INITIAL FIRE SAFETY INSPECTION REPORT

KiDO BD Co., Limited

Date: 02 January 2024

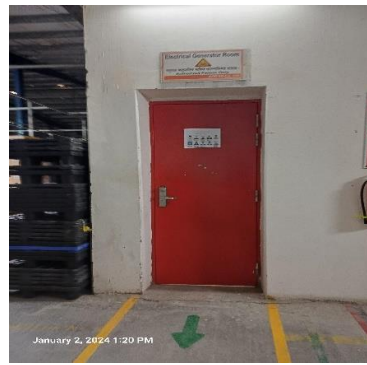
3	Fire Rated Construction	The two generator rooms located in the Generator room on the Ground floor & north-east corner of the Main Building is not separated by fire rated construction due to openings, non-rated doors, and penetrations.	Generator sets shall be separated from all other occupancy areas by a minimum 2 hour construction or by a minimum spatial separation of 3 m (10 ft) where located exterior to the building. Exhaust shall be in accordance with NFPA 37. All exhaust systems shall discharge to the exterior of the building in a safe location.	Within 3 months

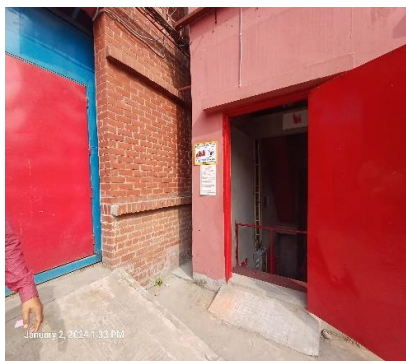
4	Fire Rated Construction	The fire pump room is not provided with adequate fireseparation. (Utility Building)	Provide fire pump room with 2 hr rated fire separation when not sprinklered and 1 hr rated fire separation when provided with automatic sprinklers, in accordance with NFPA 20. In the case exterior it shall be 50 ft away from another occupancy.	Within 3 months
---	-------------------------	--	---	-----------------

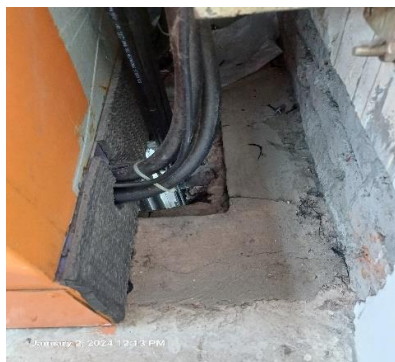
5	Fire Rated Construction	Unsealed penetrations and openings are located in the fire-rated floor/ceiling assemblies due to both sanitary line & cable riser. (Main Building)	Provide a minimum 2-hr fire rated shaft to separate the utility risers from each floor level or seal all penetrations and openings in floors/ceiling assemblies by 2-hr fire rated listed/certified materials. The installation of such fire rated materials shall be following certified design.	Within 3 months
---	-------------------------	---	--	-----------------

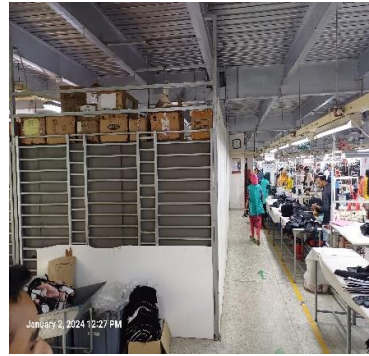
6	Fire Rated Construction	Storage of combustible materials were located at Ground floor, first floor, second floor and third floor which is not properly separated from other occupancies by fire rated construction and not maintained as per standard. (Admin Store on 1st floor; sub-store on 2nd floor; storages on 3rd floor; Cartoon store, Packing store, Warehouse & finished goods store on ground floor) (Main Building)	Separate the dedicated storage rooms by minimum 1-hr fire-rated construction. Provide 0.75 hr. fire rated door and seal all penetrations and openings by 0.75 hr. (45 Minutes) fire rated fire rated barrier construction. Where separate storage rooms are not feasible, provide defined storage areas and limit the storage arrangement as follows: - Maximum height of 2.45m (8ft.) , maximum area of 23m² (250 ft²) and 3m (10ft.) clear distance from adjacent another unenclosed combustible storage. - If the building/floor is sprinkler protected: maximum height of 3.66m (12ft.) and maximum area of 93m² (1000 ft²). -In process storage shall be limited to 10 percent of the building area of the story in which they occur.	Within 3 months

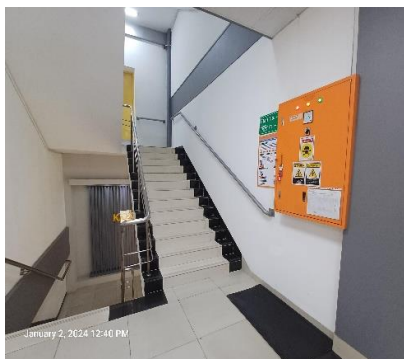
7	Fire Rated Construction	Electrical distribution panel board were located in the exit stair-1 enclosure. (Main Building)	Remove and re-locate all electrical panels & distribution board from exit stair enclosures.	Within 3 months
---	-------------------------	--	---	-----------------

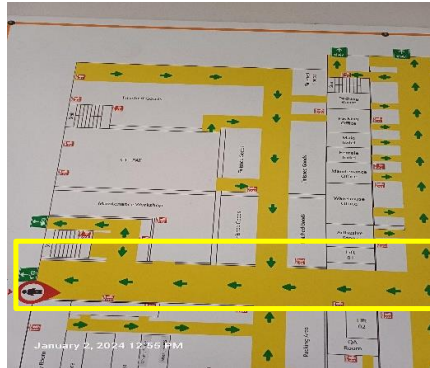
9	Fire Rated Construction	Exit access corridors serving the south exit of packing area, finished goods store & packing inspection area on the ground floor of the main building is not fire separated. (Main Building)	Exit access corridors serving an occupant load exceeding 30 shall be separated by walls having a fire resistance rating of 1 hr unless provided with automatic sprinkler protection throughout the story or building.	Within 3 months
---	-------------------------	---	--	-----------------

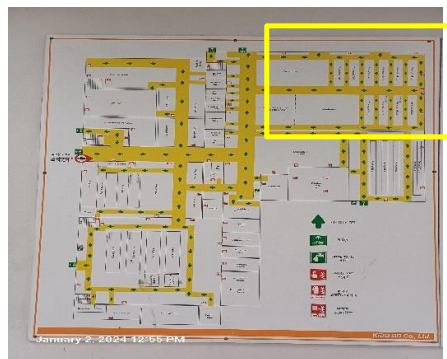
17	Means of Egress	Travel distance of egress exceeds limit on the ground floor, shed portion (warehouse) of the main building. (Main Building)	Reconfigure the egress arrangement or provide an additional exit so that the travel distance shall not exceed 23 m (75 ft).	Within 2 months
----	-----------------	--	--	------------------------

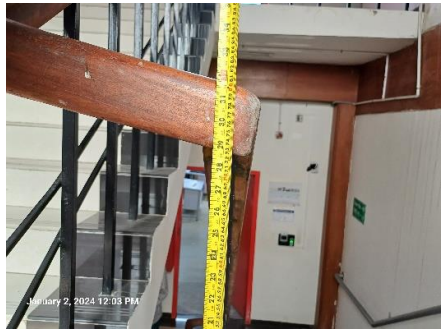
18	Means of Egress	Handrails height found 32 inches in the exit stair. (Main Building)	Provide handrails on both side of the stairs which have a minimum height of 865 mm (34 in.) and a maximum height of 965 mm (38 in.) as measured from the leading edge of the tread.	Within 2 months
----	-----------------	---	---	-----------------

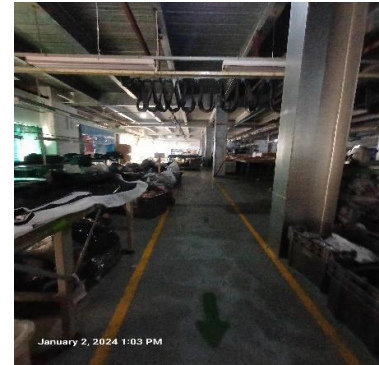
20	Emergency Lighting	Directional sign not provided at all required locations on the 1st floor. (Main Building)	Provide directional exit signs above all building exits to the exterior, all doors to the exit stairs and along all paths of travel where a change of direction is not obvious. Lighted directional signs shall be provided with either battery backup or uninterruptable power supply systems and shall be continuously illuminated.	Within 1 month
21	Emergency Lighting	Based on the number and location of emergency lights observed, adequate illumination levels are not anticipated along egress routes and at exit stairs on all floors. (All Building)	Test the emergency lighting system on each floor and provide additional emergency fixtures to supply adequate illumination along the means of egress. Provide a minimum illumination of 10 lux at the floor level within exit stairs and along exit discharge paths and a minimum 2.5 lux along exit access aisles.	Within 2 months

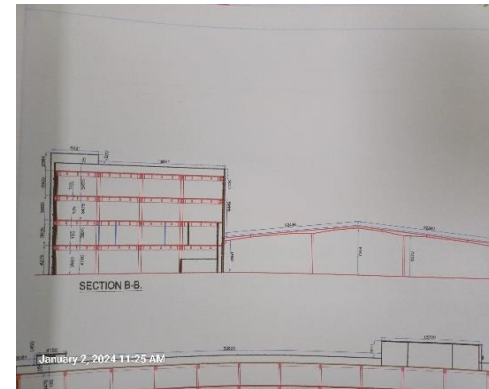
24	Fire Protection System (Standpipe)	The building has highest occupiable floor level more than 11 meter (33 ft.) which requires standpipe system. (Main Building)	Submit the standpipe system drawing to RSC for review. Once the design is reviewed, install and modify the standpipe system throughout the building in accordance with review comment, RSC Standard and NFPA 14, 20, 22 and 24. After installation the owner shall conduct internal testing and commissioning and then contact the RSC for witness of final acceptance testing.	Design Review within 2 month and installation within 4 months (If require).
----	------------------------------------	---	---	--
